**Louisville - Southern Indiana Ohio River Bridges Project
Kentucky Historic Preservation Advisory Team
Meeting – December 14, 2006
TARC Administration Building**

Aesthetic Design Guidelines – Kentucky East End: Jerry Leslie, HW Lochner; Jim Klein, Lardner-Klein; Chris Amos, Burry & Amos

Design Section 4 EAST END KENTUCKY APPROACH

Design Section 1
KENNEDY INTERCHANGE

Section 7

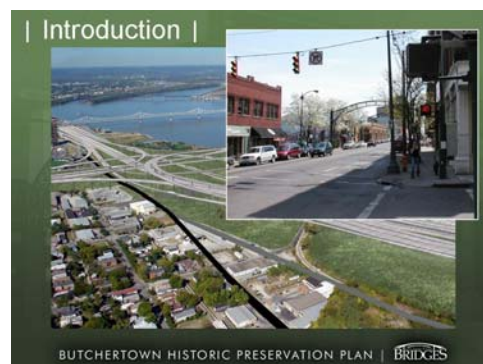
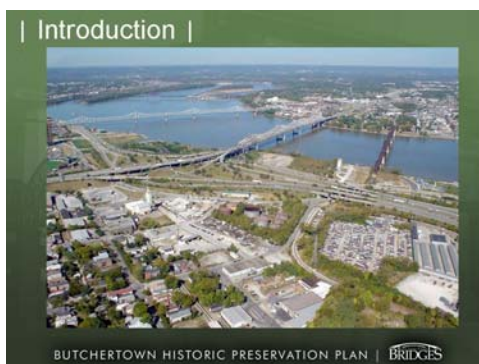
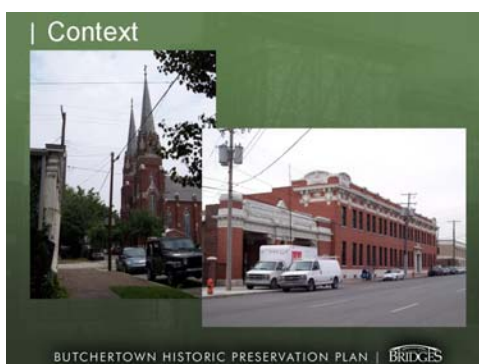
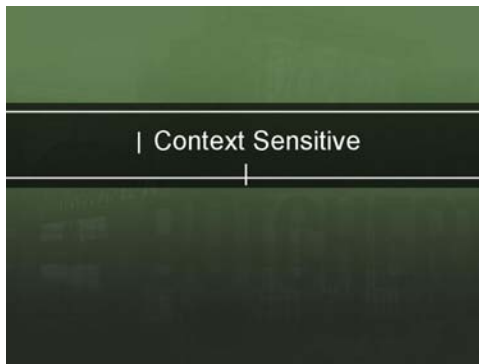
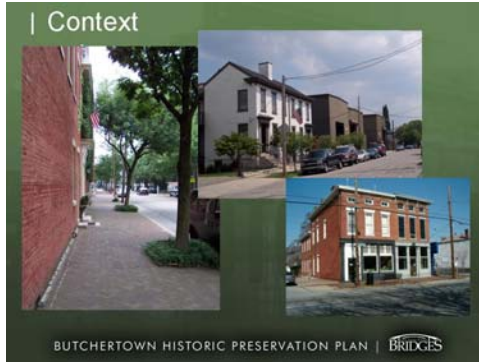
- Liberty Green open for HUD noise mitigation
- Section 7 of SDC 1 noise analysis identified feasible wall from the ramp of Mellwood to R/R overpass (Clifton). Motion made by J. Segrest to discourage further consideration of barrier and meeting with Clifton Neighborhood. Motion did not carry.

- BT/PH need to explore other avenues to solving noise problems.
- SDC 1 to meet with Clifton Neighborhood and report results to KHPAT.

Mr. Kersey commented he felt the noise walls were worse than the noise problem. Following this comment, attending members agreed the SDC 1 Kennedy Interchange Design Team should talk with Clifton Neighborhood about the issue.

Mr. Sutherland noted that the BSMT has eliminated from consideration barriers in Sections 1-6 and 8-9. However, Section 7 of the noise analysis identified a feasible wall from the ramp of Mellwood Avenue to the railroad overpass, adjacent to the Clifton neighborhood. Mr. Sutherland indicated that the intent of this discussion was to gain a recommendation from the KHPAT on how to pursue a resolution to the Section 7 barrier and whether to meet with Clifton. A motion was made by Mr. Segrest to discourage further consideration of this barrier and meeting with Clifton neighborhood. The motion did not carry. It was noted by Mr. Segrest that Butchertown and Phoenix Hill need to explore other avenues to solving noise problems. SDC 1 will attempt to arrange a meeting with the Clifton Neighborhood Association and report the results to the KHPAT.
